NOTICE OF PUBLIC HEARING **Minor Variance**

APPLICATION NO.: SC/A-21:344

SUBJECT PROPERTY: Municipal address **197 Lewis Rd., Stoney Creek**

PROPOSAL: To permit the construction of a new single detached dwelling upon demolition of the existing single detached dwelling and accessory building, notwithstanding,

SKETCH SHOWING PROPOSED DWELLING
(197 LEWIS ROAD)

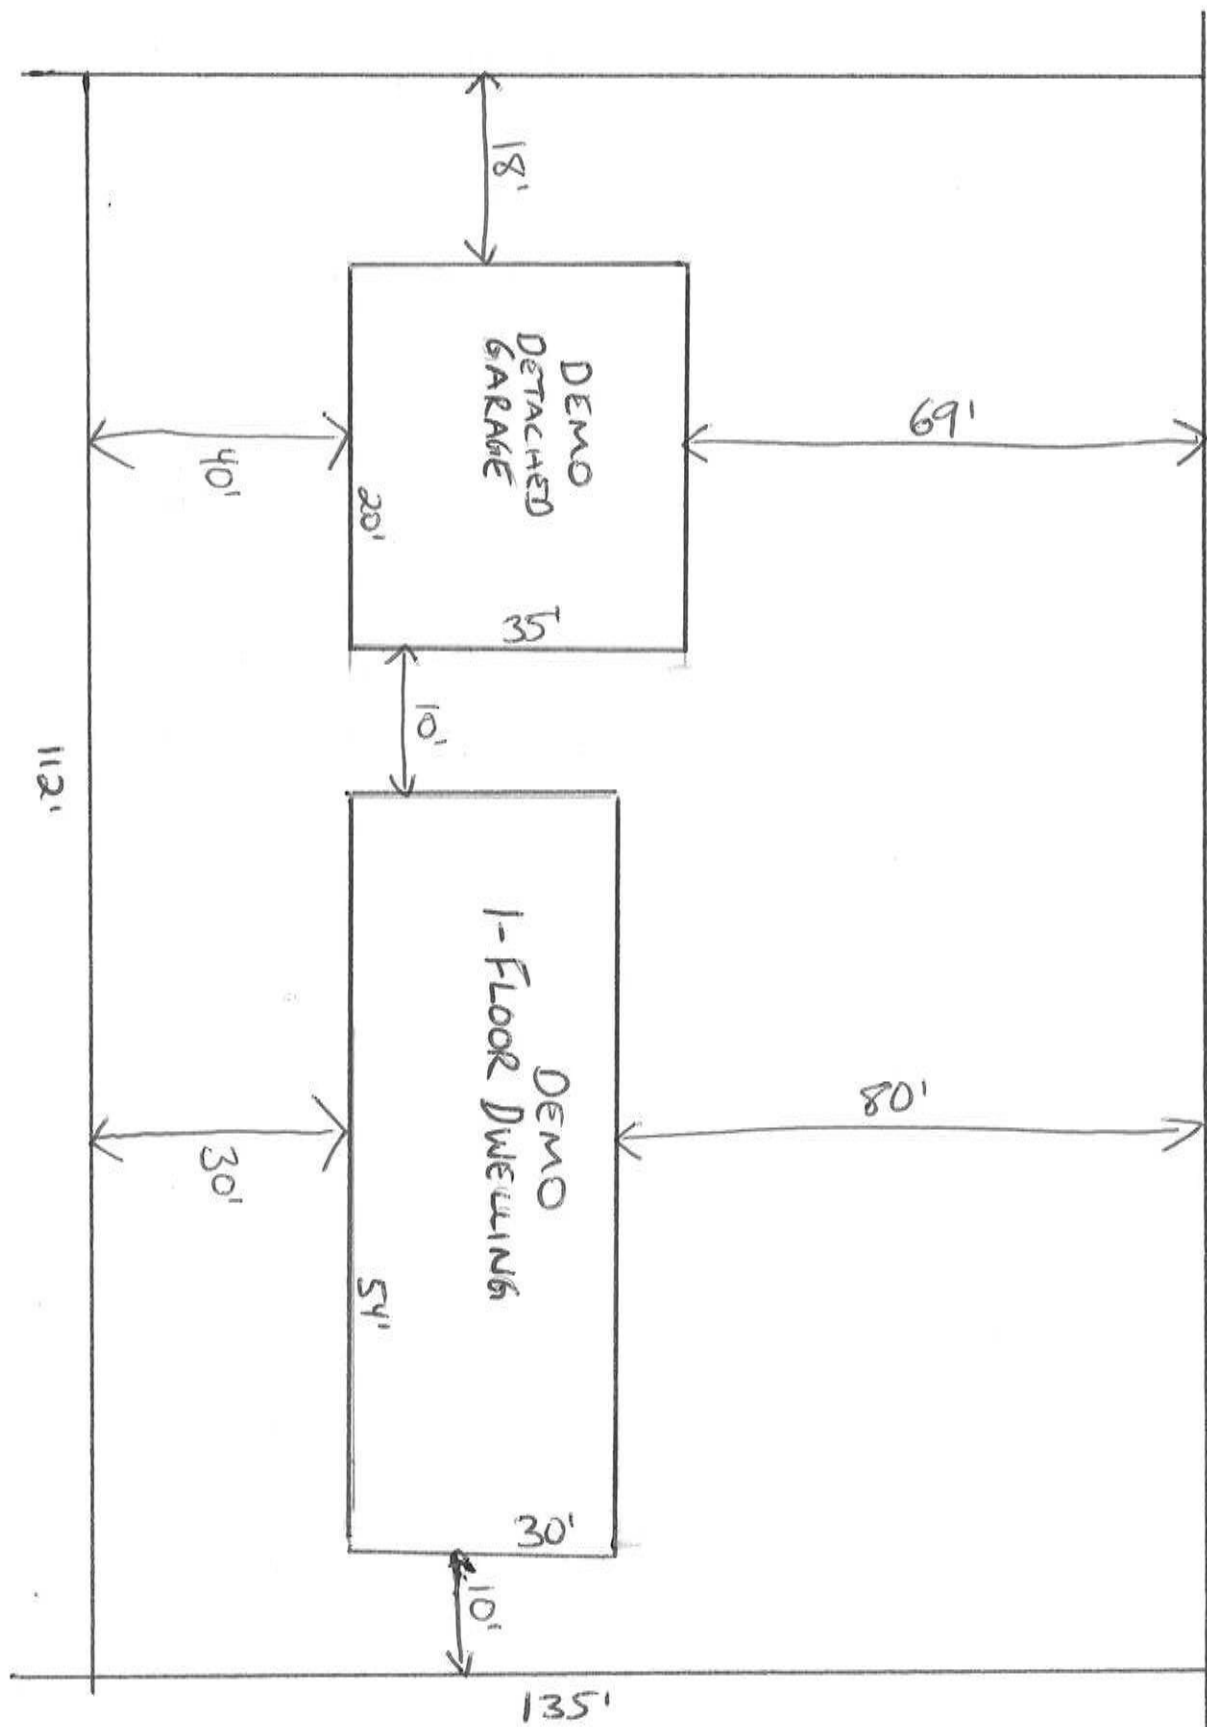
2. Details with respect to the location of the required parking space are not provided. It is assumed one (1) unobstructed parking spaces with dimensions of 2.80 m by 5.80 m will be provided within the attached garage located more than 5.80 m from the front lot line. Additional variances may be required if parking space design standard is not a minimum of 2.8 m by 5.8 m. Further variances may be req'd if parking is to provide elsewhere on the site.

3. A further variance may be required if all other portions of the front yard other than the driveway area not be provided as "Landscaping" as defined below.

4. It's unclear if the existing driveway shown on the site plan is intended to be maintained. Further variances may be required if the existing driveway is intended to be maintained.

6. Details have not been provided regarding the eaves and gutter projections within front yard, rear yard, southerly side yard, and northerly side yard. Further variances will be required if compliance with Section 4.6 (a) which allows for a projection of no more than 0.60 m into the required yard or a maximum of half the distance of the required yard, whichever is the lesser is not satisfied.

7. The surface material of the driveway is not specified on the submitted site plan. Surface appears to be asphalt, however, full confirmation is required.

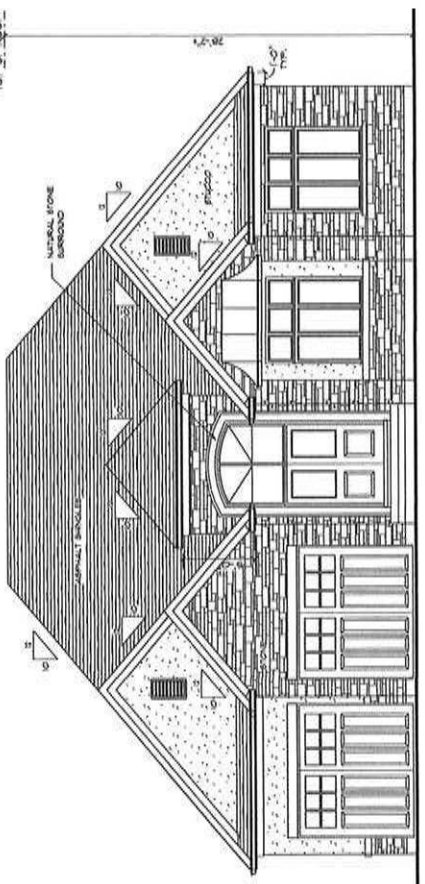
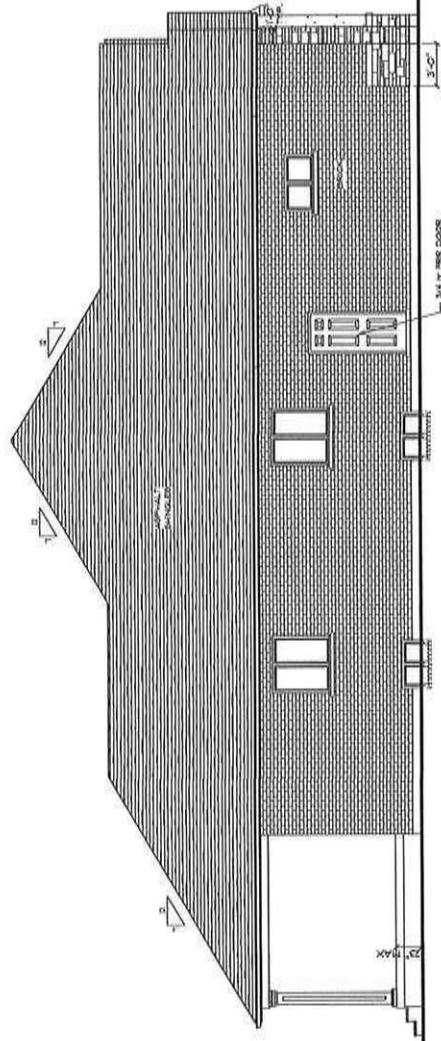
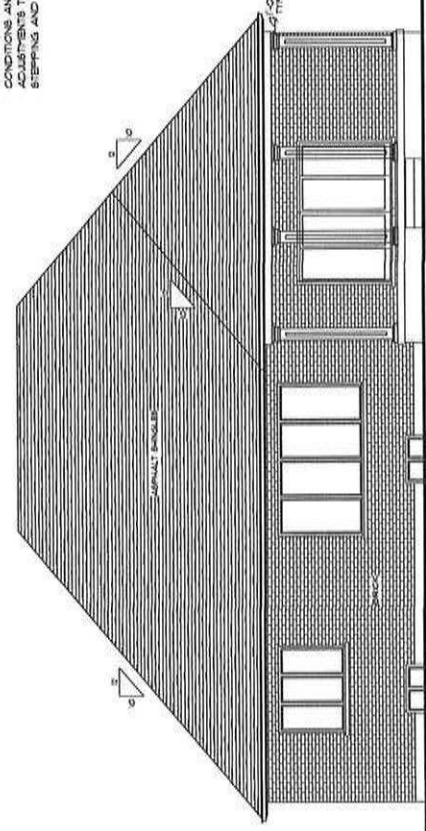
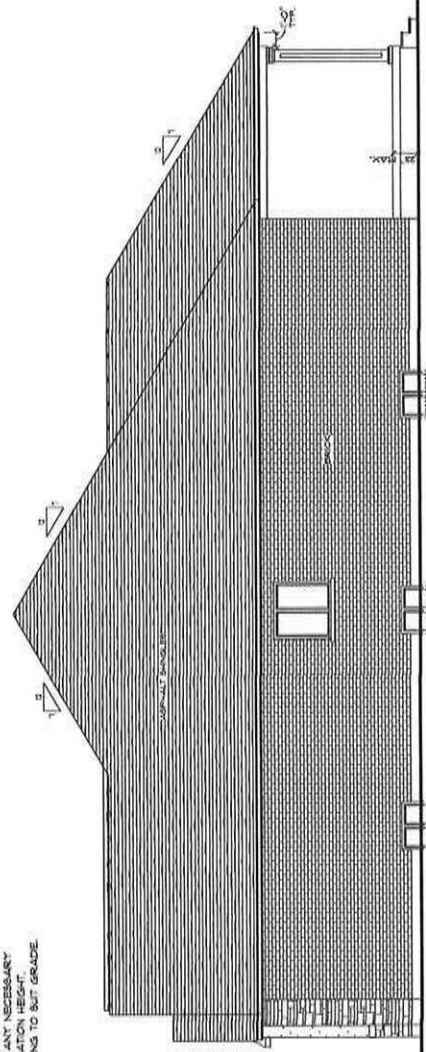
5. The submission is deficient of elevation drawings to which it is not clear if the height of the proposed single detached dwelling complies with the maximum permitted height of 10.5 m pursuant to Section 12.1.3.3(c). Additional variances may be required if the building height exceeds 10.5 m measured in accordance with the definition in the zoning by-law.
